UNITED STATES OF AMERICA
NUCLEAR REGULATORY COMMISSION

In the Matter of)	
)	
CONSOLIDATED EDISON COMPANY OF NEW YORK, INC.)	Docket Nos. 50-247-SP
(Indian Point Unit 2))	50-286-SP
)	
POWER AUTHORITY OF THE STATE OF NEW YORK)	7 February 1983
(Indian Point Unit 3))

UCS/NYPIRG TESTIMONY OF STEVEN C. SHOLLY
ON THE CONSEQUENCES OF ACCIDENTS AT INDIAN POINT
(Commission Question One and Board Question 1.1)

INDIAN POINT 3	FSAR UPDATE
POPULATION DISTRIBUTION 5 MILE RADIUS BASED ON JUNE 1972 REPORT	
REV 0	JULY 1982
	FIGURE NO. 2-4-3

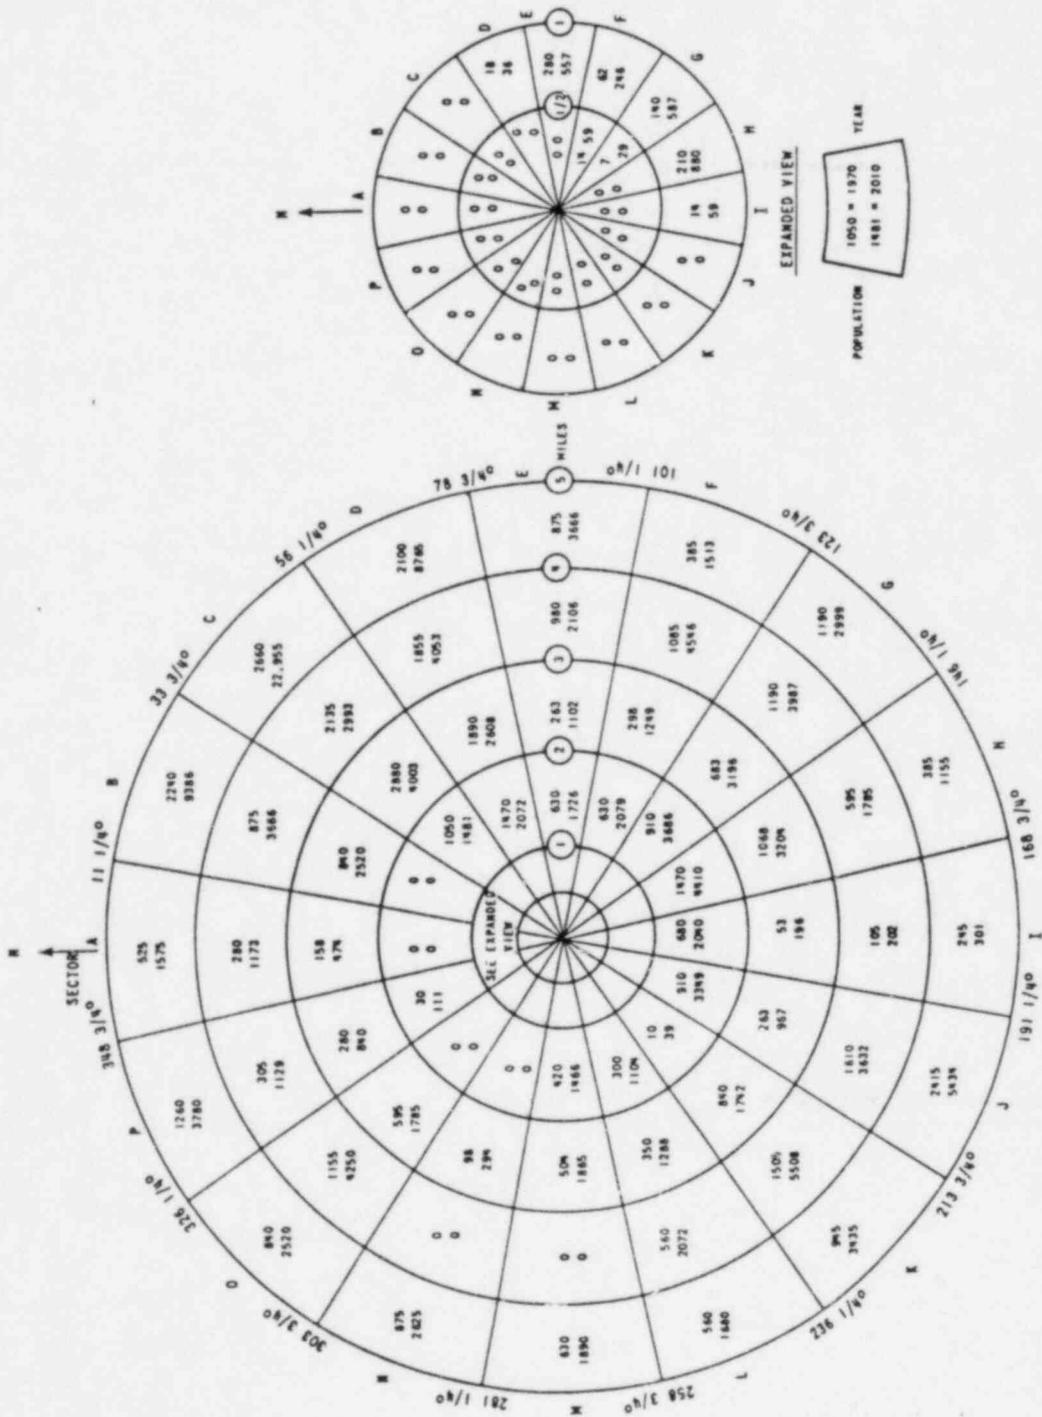
A set of projections for the population in the region surrounding Indian Point is found in the Indian Point Unit 3 "FSAR Update" [FSAR UPDATE, page 2.4.P-5, and Figures 2.4-3 and 2.4-4]. Cumulative ring totals as well as estimates by grid location are provided through the year 2010 (the nominal end of operating lifetime for the Indian Point reactors). These estimates (Attachments 1 through 3) show that substantial changes in both magnitude and distribution are expected between 1980 and 2010. The impact of these changes on consequence estimates requires further investigation.
